**Assessment of and Protection Recommendations for 13 Regulated Trees
At And Adjacent To**

**116 Vallecitos
Los Gatos, California**

**SEE MY
RESPONSES IN RED
BELOW**

Report by CTA
12/16/2025

28

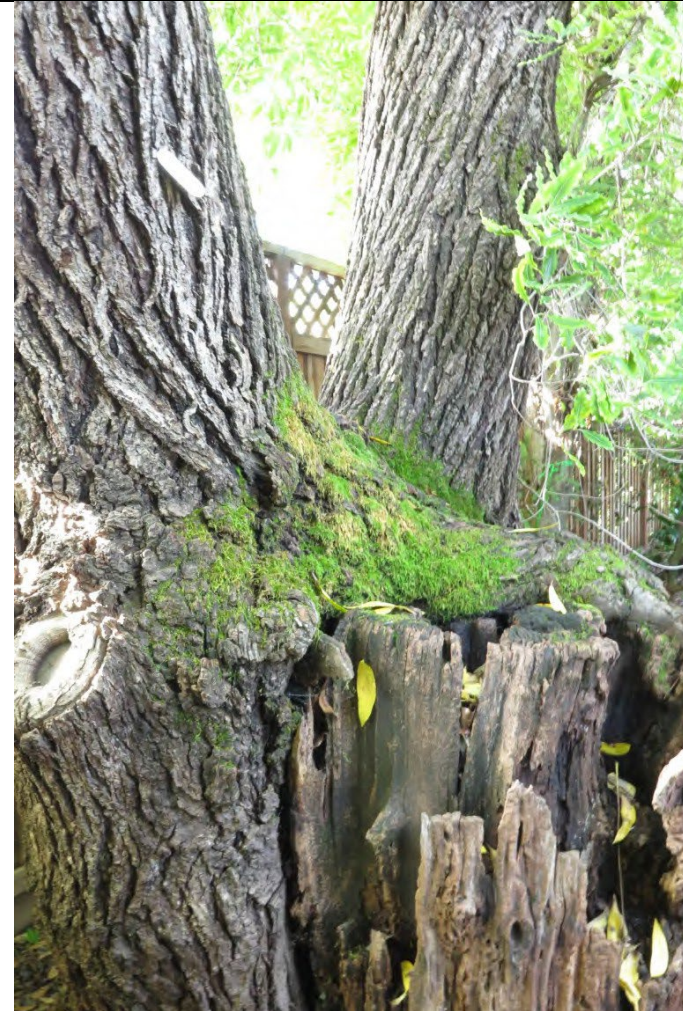
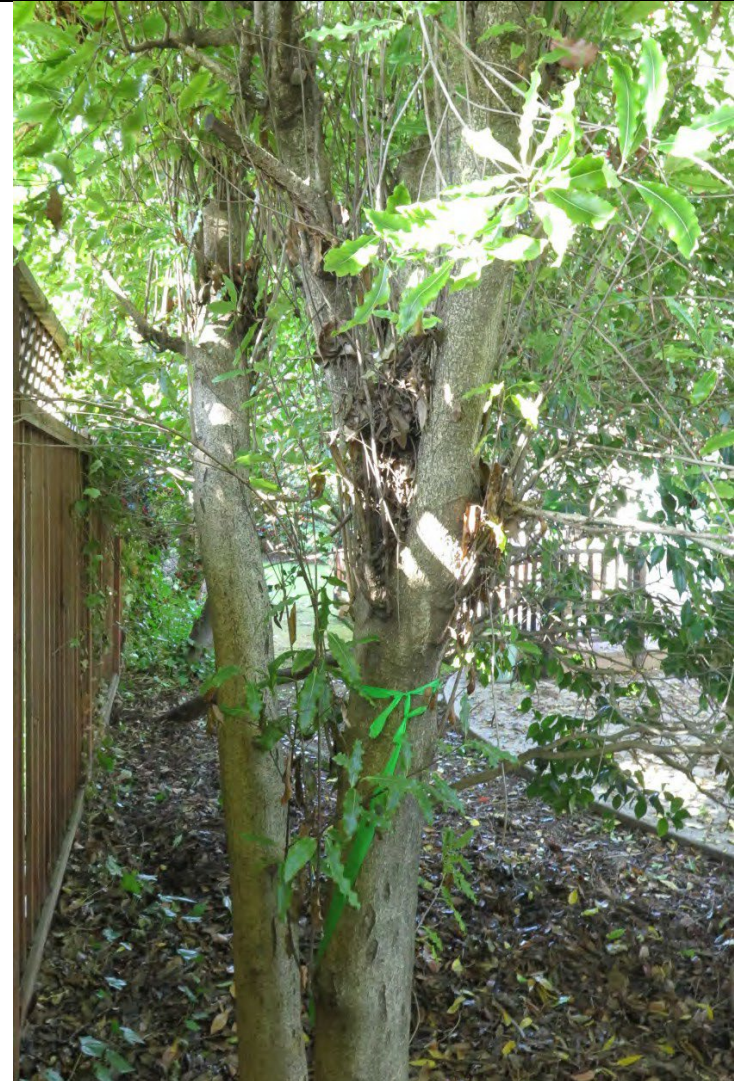
- Tree 28 is a very large specimen of native Northern California black walnut with very extensive wood tissue decay progression in the lower mainstem area where a third mainstem was removed at 4 feet elevation in the past. The tree has been extensively pruned by PG&E to clear the overhead high voltage electrical wire right of way. The remaining remnant tree has a compromised structural root system with visible decay in the lower trunk, and a canopy that is lopsided northward toward the proposed residence. The CTA recommends removal of this tree for safety purposes.

The tree is considered either a “moderate” or a “high” TRAQ risk in terms of likelihood of tree or tree part failure and impact with high value targets, causing significant to severe damage. Risk rating determination is outside of the scope of this CTA arborist report preparation assignment. However,

for the purposes of this report, the tree is suggested to be considered by Town Staff to be a “high risk” tree specimen, which allows the tree to be removed as a no-fee removal with no canopy replacement plantings required by the applicant. See box on report page 4 below for details.

Table 1.0(a) **WE ARE PLANNING TO KEEP THIS TREE**

12.0 Tree Map Mark-up by the CTA (2025) on Applicant Site Plan Sheet 4 of 19

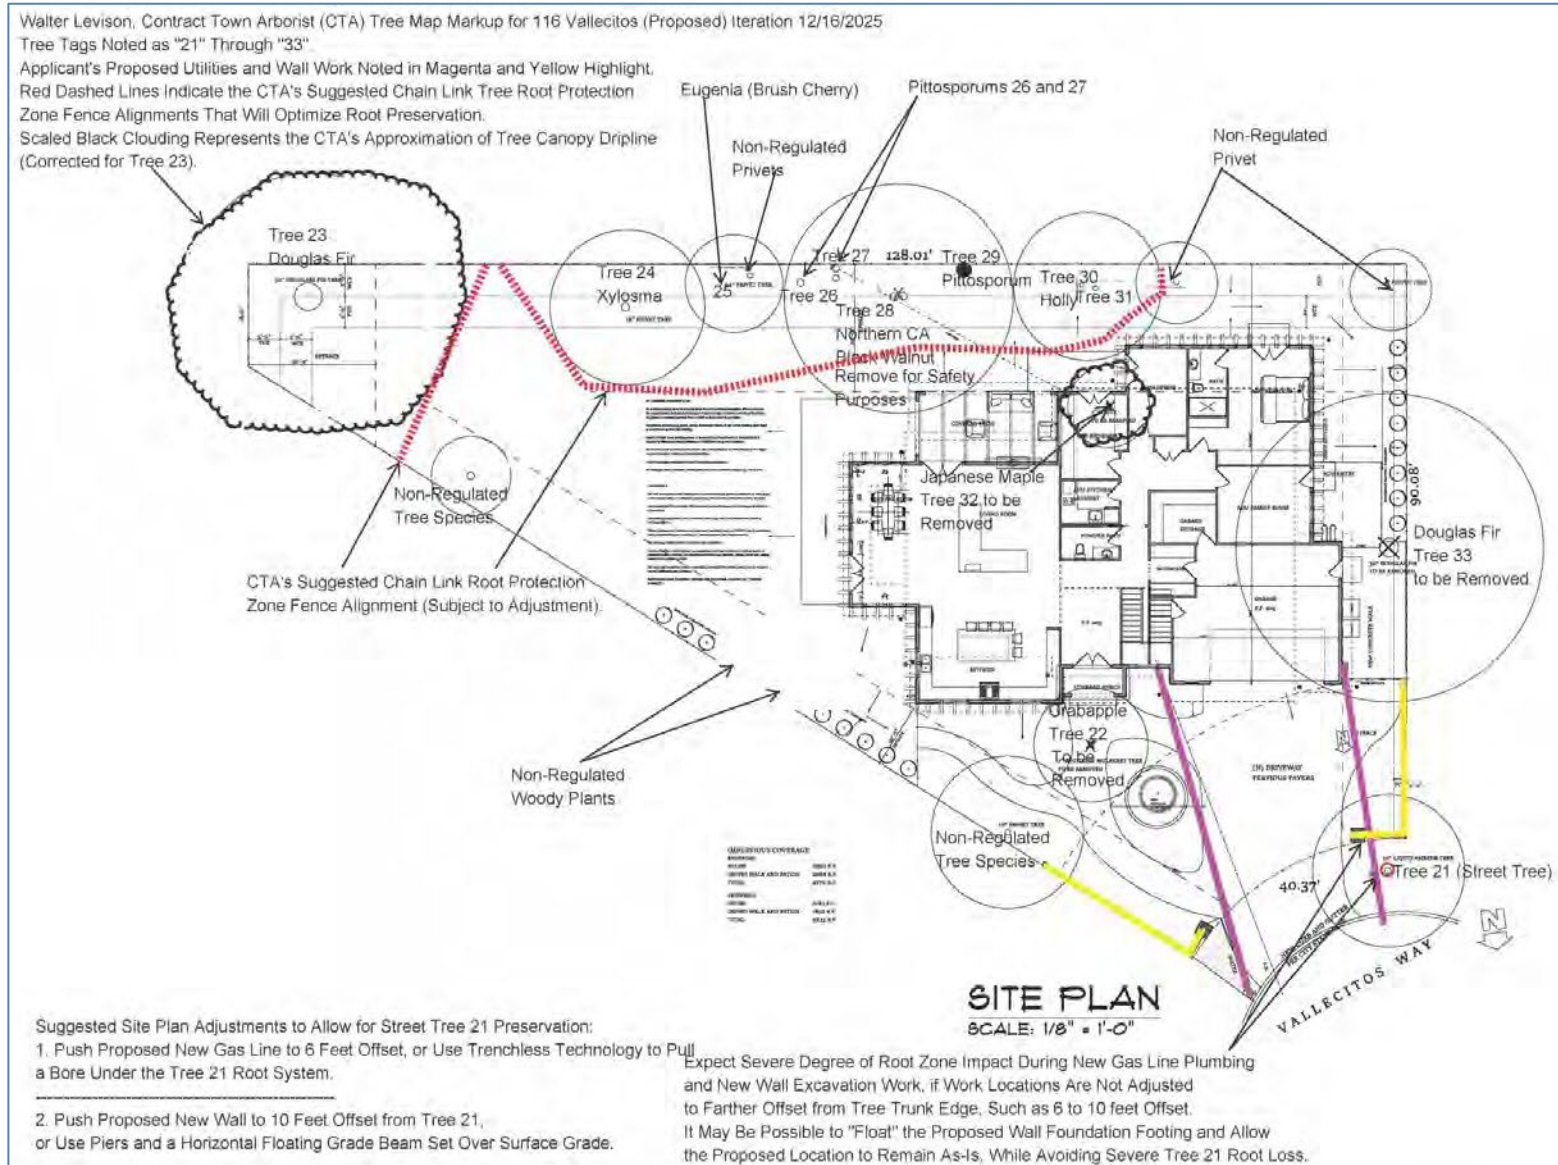
- Tree 21 may experience severe negative impacts if the proposed new gas line trenching and proposed new property line wall are built out at the current proposed locations shown on the applicant’s site plan sheet 4 of 19.

The CTA suggests either pushing these two items farther offset from the mainstem of tree 21, such as 6 feet offset for gas line and 10 feet offset for wall work.

If relocation of the gas line and/or wall position is/are not possible, then “trenchless technology” could be utilized to safely bore the gas line underneath the root system of the tree at depth such as at 3 to 4 feet depth, and a “floating over-grade beam suspended on vertical piers” could be used to build the proposed new wall above the lateral woody root system of the tree.

- GAS PIPE: Adjust the gas pipe alignment to at least 6 feet offset from trunk edge of street tree #21, or use trenchless technology to bore the gas pipe underneath the tree’s root system at depth. **THIS IS NOTED ON SITE PLAN**
- PERIMETER WALL: Adjust the location of the property line wall near street tree #21 such that it is 10 feet offset from the trunk edge, or alternatively, build the wall as a floating system that uses an over-surface-grade beam suspended on vertical piers, such that the work is completely above existing soil surface grade elevation, thereby allowing the tree #21 lateral woody root system to be preserved in the area south of the tree.
NOTES ADDED TO SITE PLAN ABOUT FENCE NEAR THIS TREE

All other trees are to be protected in place using the CTA’s red dashed lines on the tree map markup in section 12.0 of this report as basis for erection of chain link standard robust fencing throughout the entire demolition and construction periods. In most cases, the CTA attempted to show the root protection zone fence lines as red dashed lines drawn at or beyond each tree’s “critical root zone” offset radius, defined as 6 times the trunk diameter, measured horizontally outward from the trunk edge of each tree. **TREE PROTECTION SHOWN ON SITE PLAN PER THIS REPORT**

No storage, staging, work, or other activities will be allowed inside the RPZ except with PA monitoring.
ADDED TO SITE PLAN
